**North Liberty
Planning
Commission
Meeting Information**

NORTH LIBERTY PLANNING COMMISSION
MEETING NOTICE AND AGENDA
Tuesday, July 5, 2016, 6:30 PM

To: North Liberty Planning Commission
From: Dean Wheatley, Planning Director
Subject: Site Plan Approval Request
(Proposed lot 1, Roseberry Stop)

PAD SITE PLAN ROSEBERRY STOP, LOT 1 NORTH LIBERTY, IOWA

SITE LAYOUT AND DIMENSION PLAN

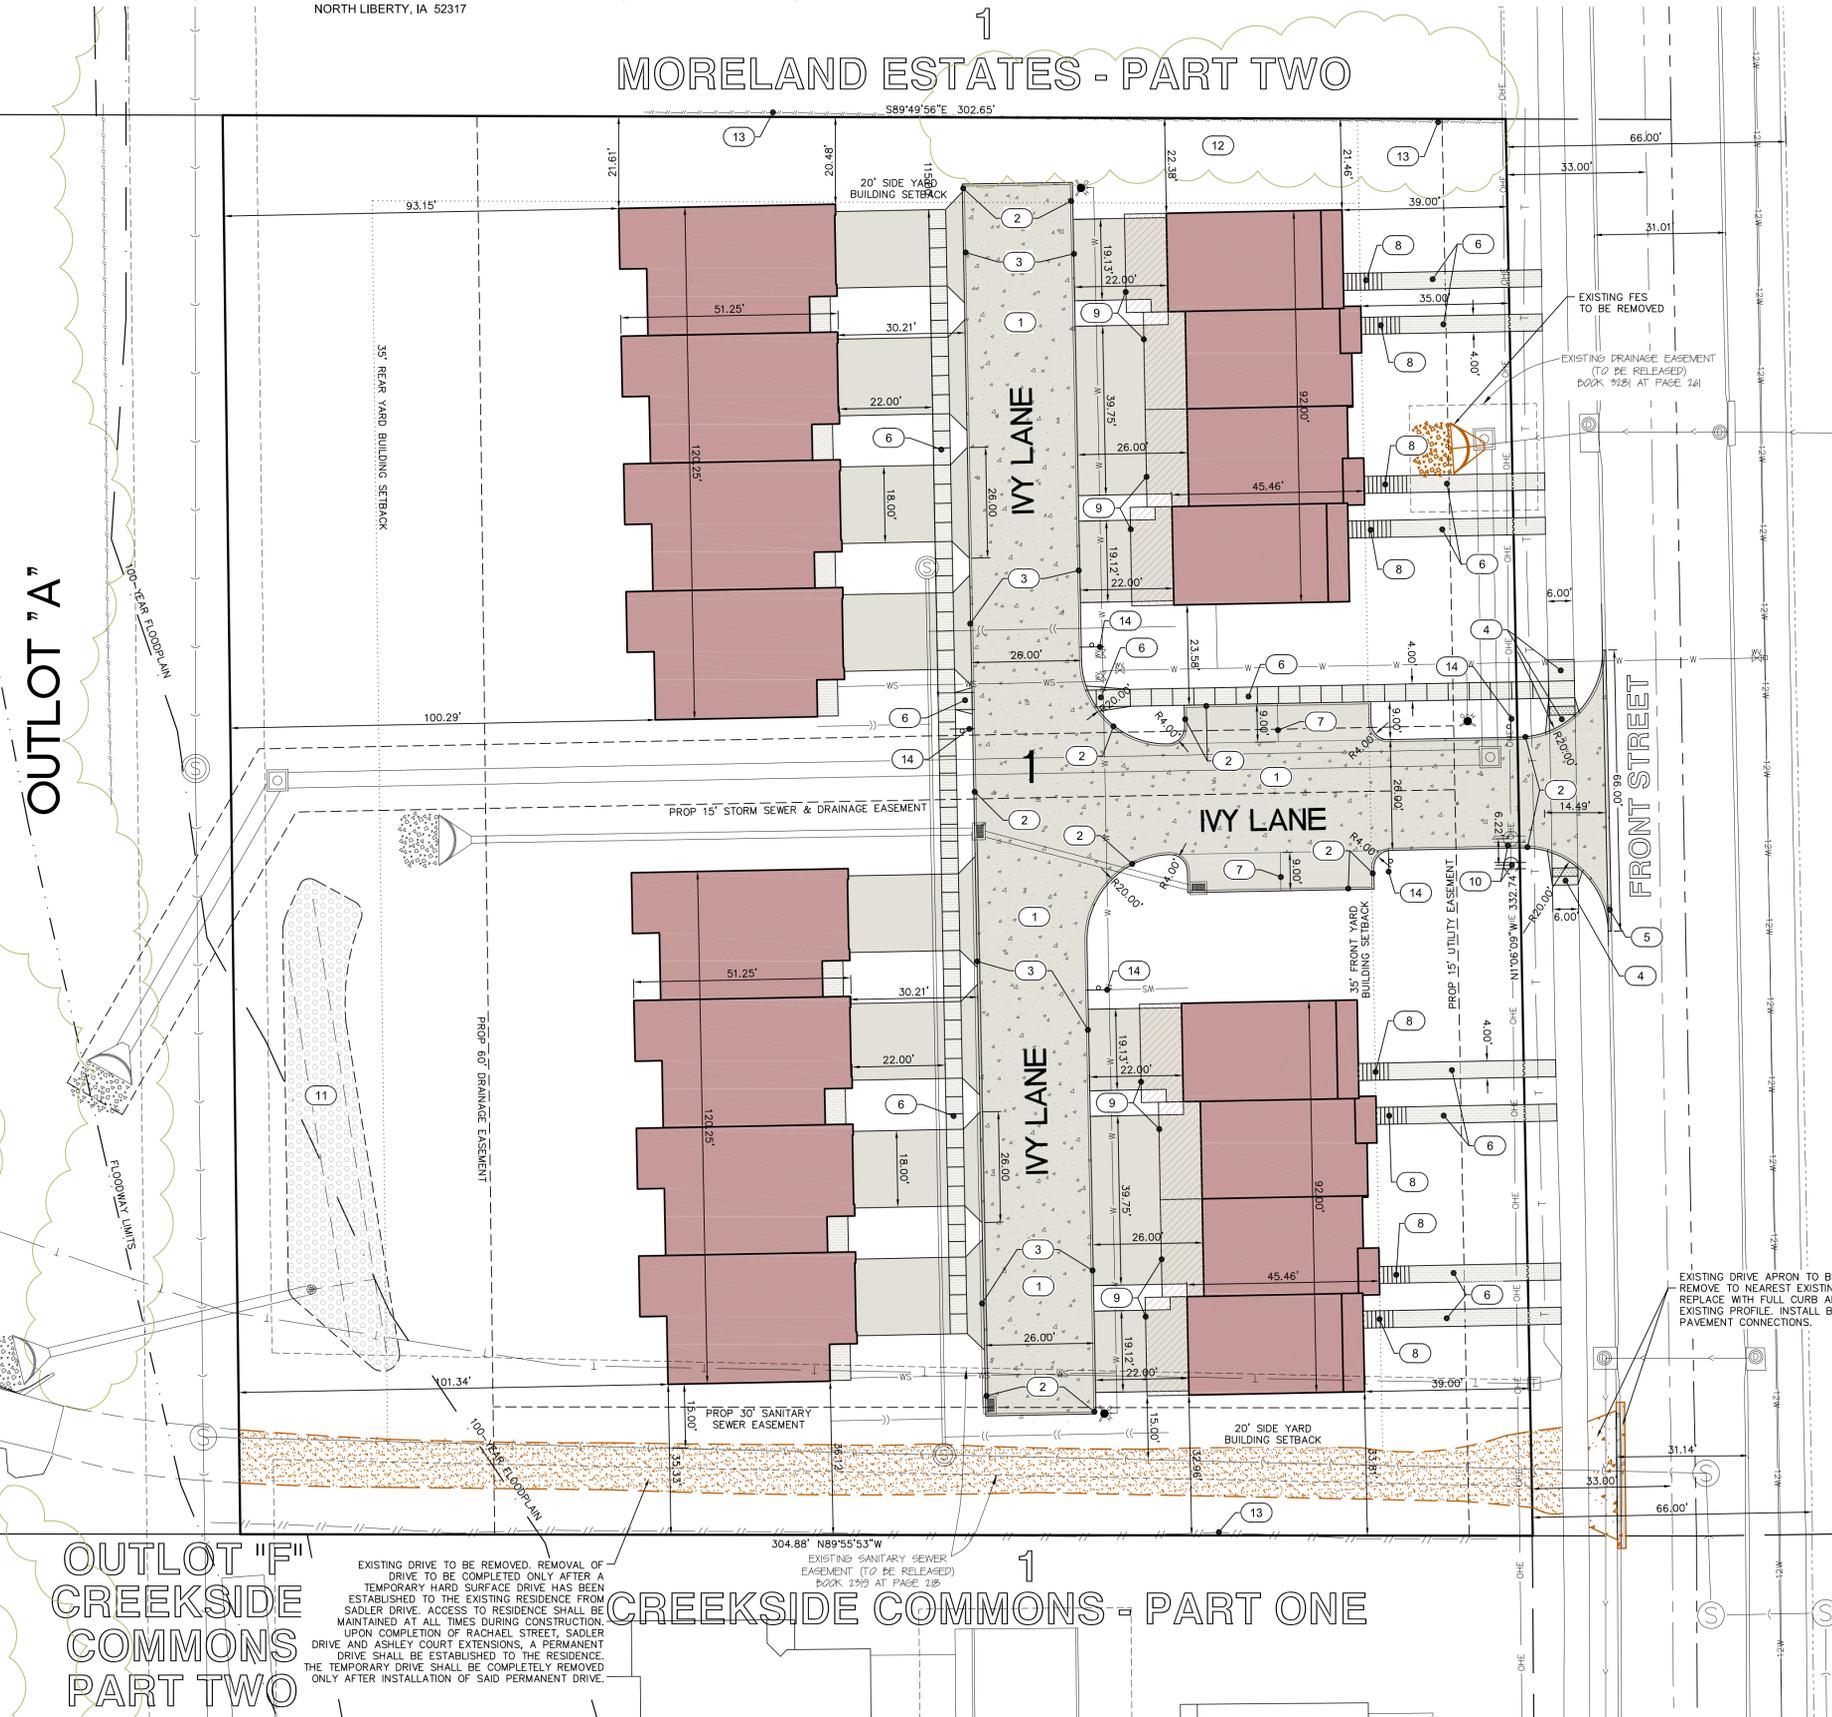
This request from Francis and Christine Lenane to approve a site plan for multi-family property located on the west side of South Front Street, just north of Creekside Commons condominiums. The zoning is RM-8 PAD, multi-family, and this site is part of a larger overall property that extends west to the CRANDIC railroad. Muddy Creek bisects the larger Lenane property north to south, and the creek and timber are immediately west of the proposed condominiums.

A site plan was previously approved for this location some time ago but has since expired, and this plan is very similar but updated where necessary to meet current ordinance requirements. That plan had 19 smaller units on this same site now proposed for 16 units, and did not include sidewalks or extra parking found on the new plan. Visually, this site will lay out much like the Creekside Commons development to the south. Zoning Ordinance requirements are met.

The buildings are an attractive rowhouse design with generous windows, roofline changes, offsets, masonry, and porches, and will be an asset in the area.

Staff recommends approval of the site plan.
